Subject: Comments On the Tentative Order For Renewal of the City of Lathrop's Waste Discharge Requirements and Master Reclamation Permit

Revised figures: Attachments E, F, G, H and I

**City of Lathrop Consolidated Treatment Facility and Water Recycling System, San Joaquin County
Comments Regarding Tentative Order For Renewal of the City of Lathrop’s Waste Discharge
Requirements and Master Reclamation Permit**

GROUNDWATER MONITORING WELL MAP
 CITY OF LATHROP
 CONSOLIDATED TREATMENT FACILITY
 SAN JOAQUIN COUNTY

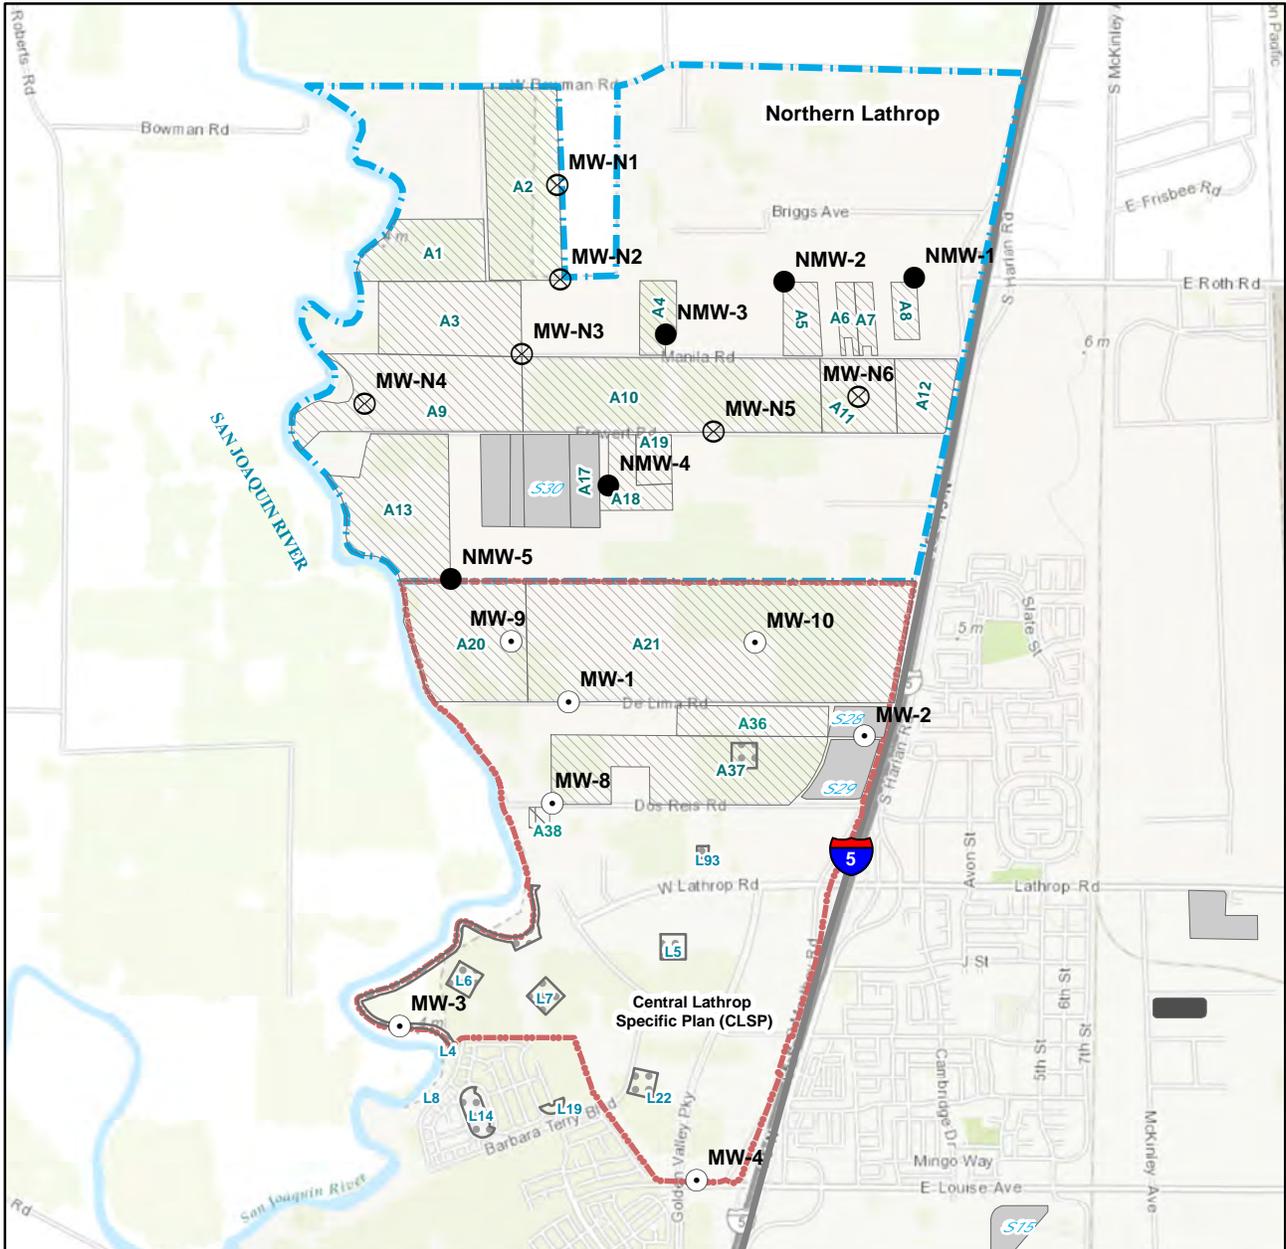
TO Permit - Attachment E

This attachment has been revised to exclude abandoned/destroyed wells (please see attached).

**PLANNED NORTH LATHROP AND
 CLSP USE AREA SITE PLAN**

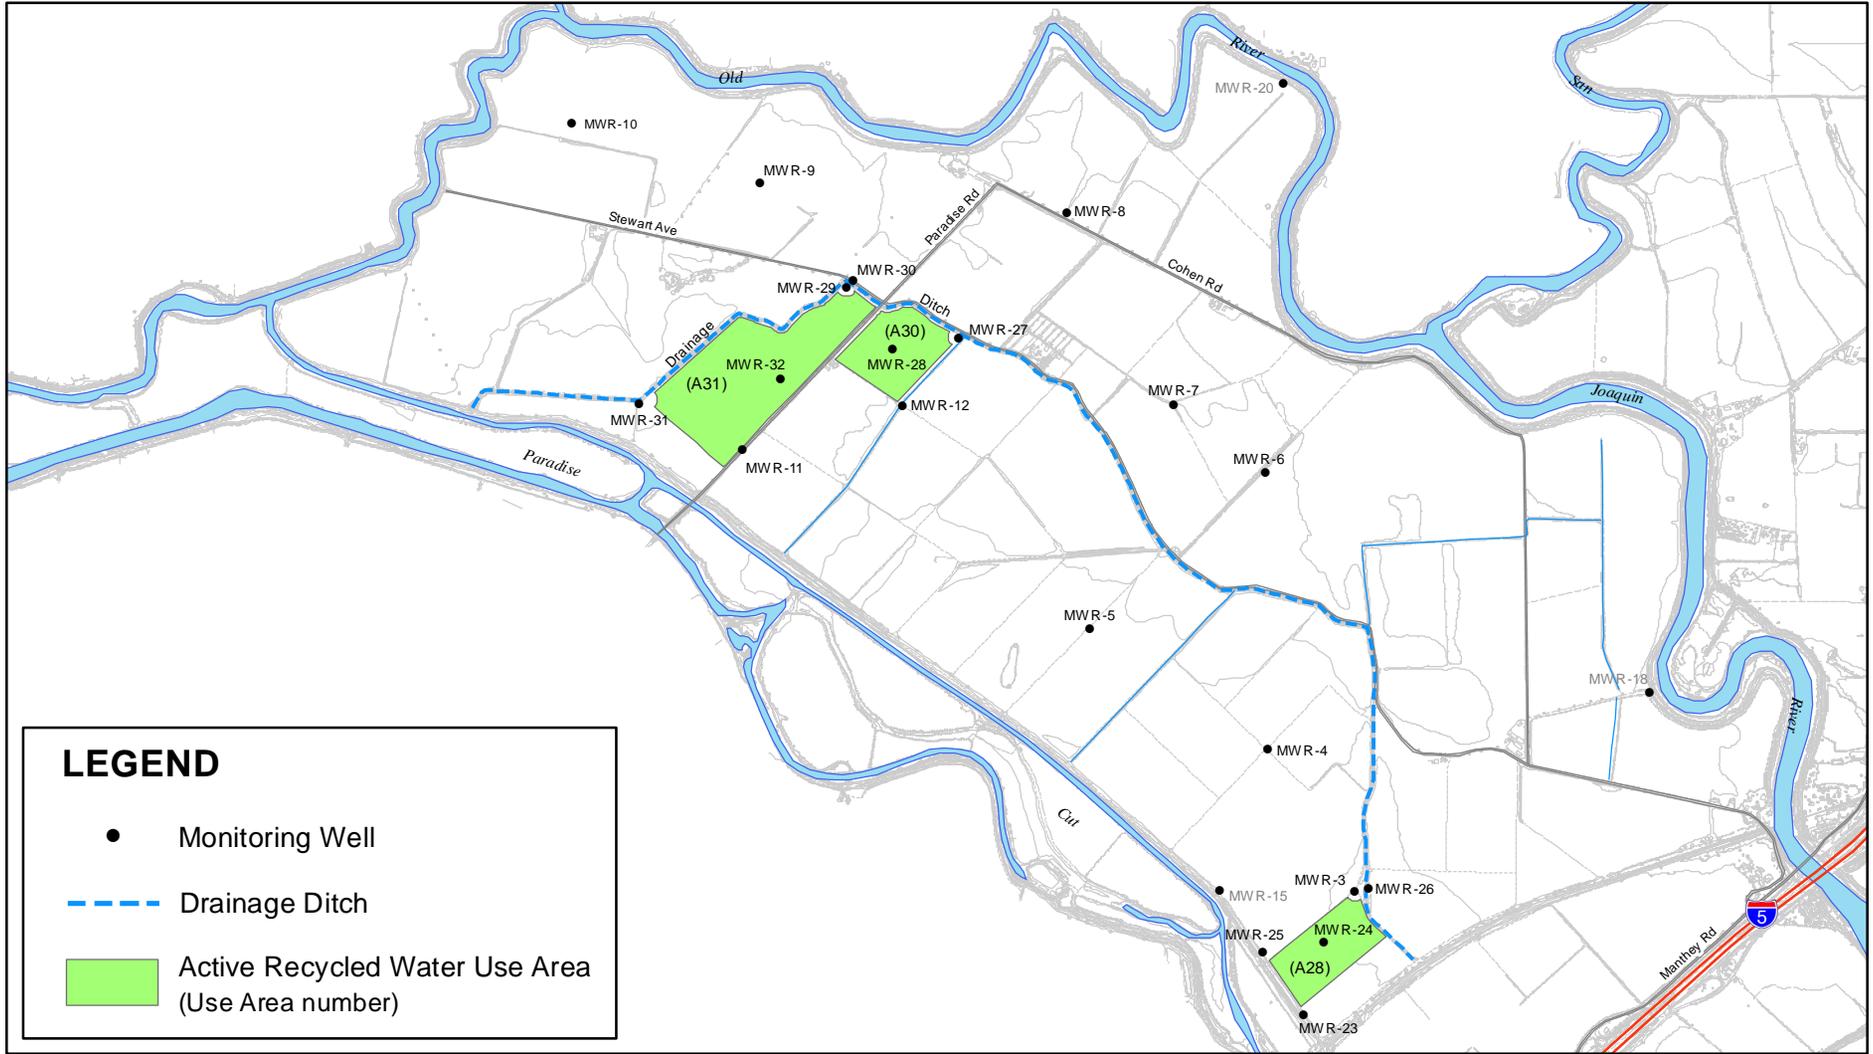
TO Permit - Attachment F

This attachment has been revised to exclude abandoned/destroyed wells, proposed monitoring wells and direct push locations (please see attached).

RIVER ISLANDS USE AREA PLAN

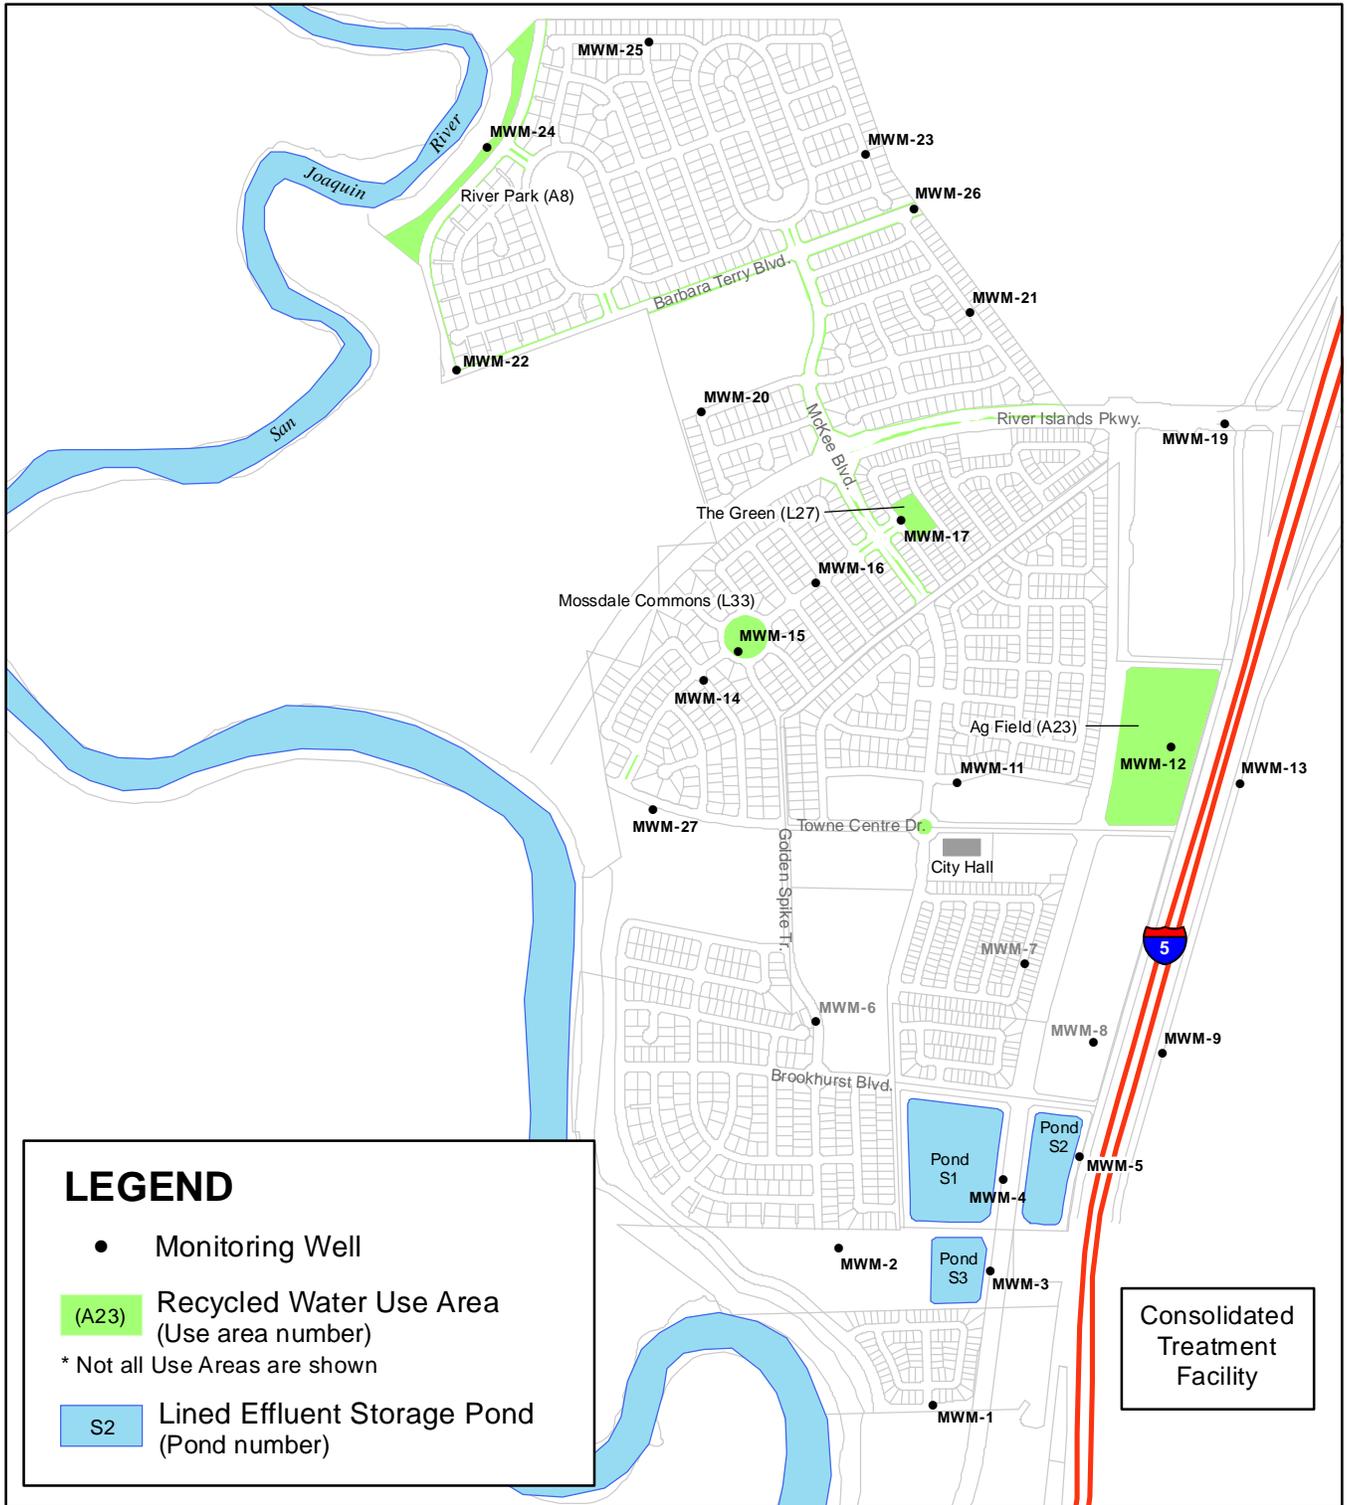
TO Permit - Attachment G

This attachment has been revised to exclude abandoned/destroyed wells and surface water monitoring sites (please see attached).

GROUNDWATER TDS MAP
 CITY OF LATHROP
 CONSOLIDATED TREATMENT FACILITY
 SAN JOAQUIN COUNTY

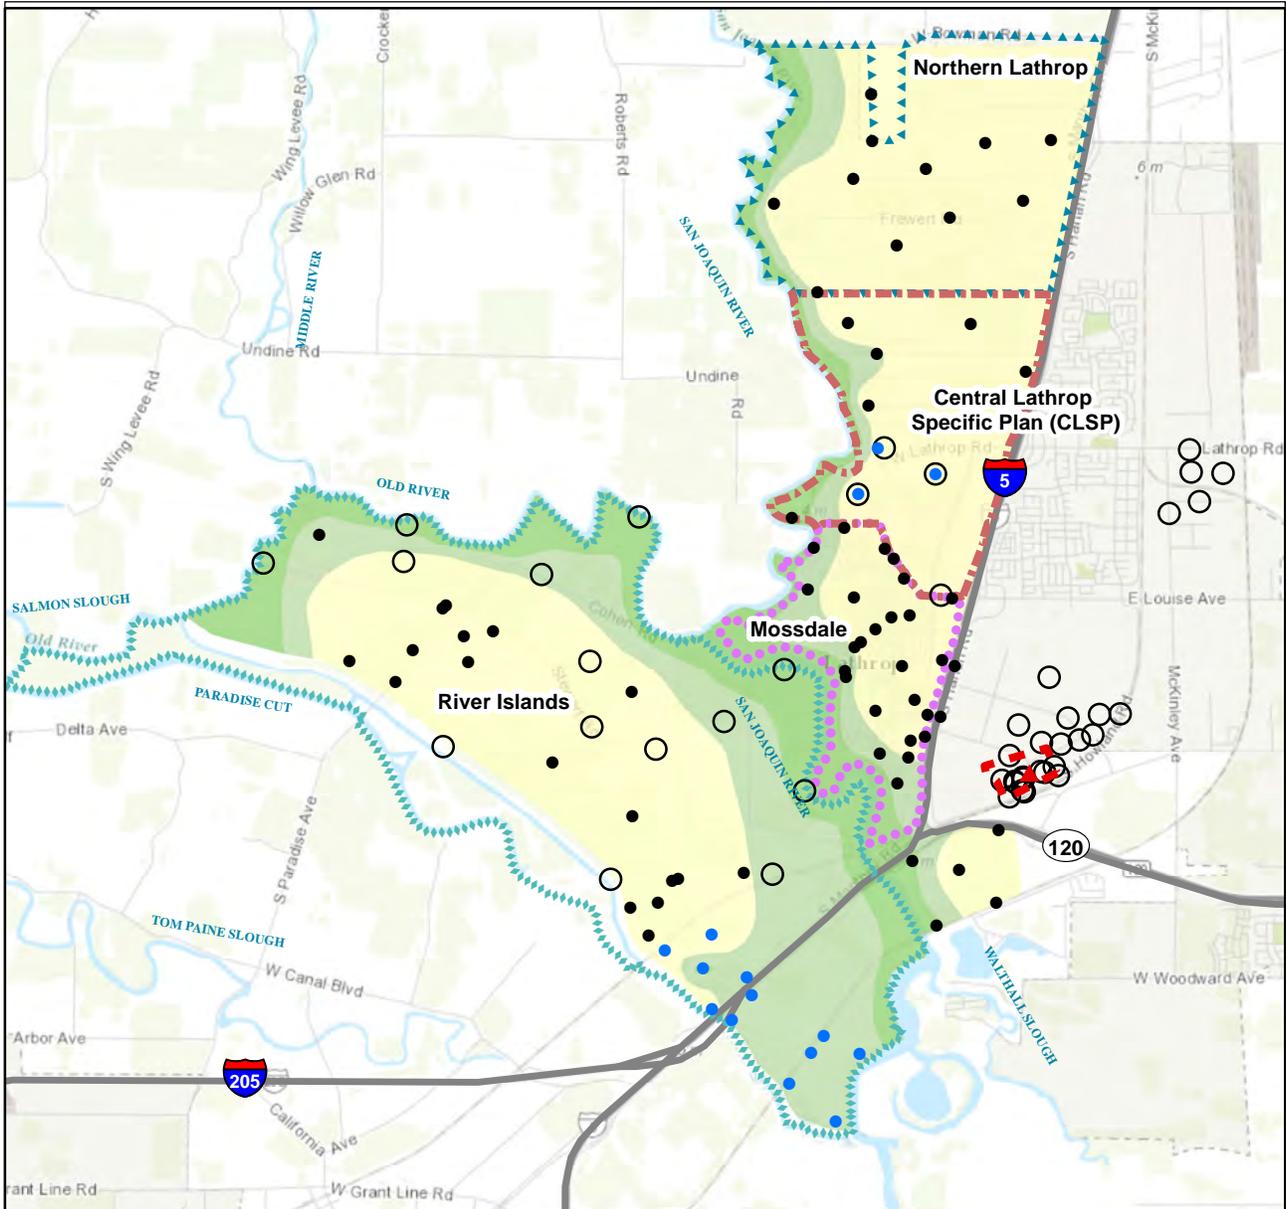
TO Permit - Attachment I

This attachment has been revised to clarify the groundwater wells / grab samples that are used in the interpretation of the TDS zones and the wells that are not used in the interpretation of the TDS zones (please see attached).
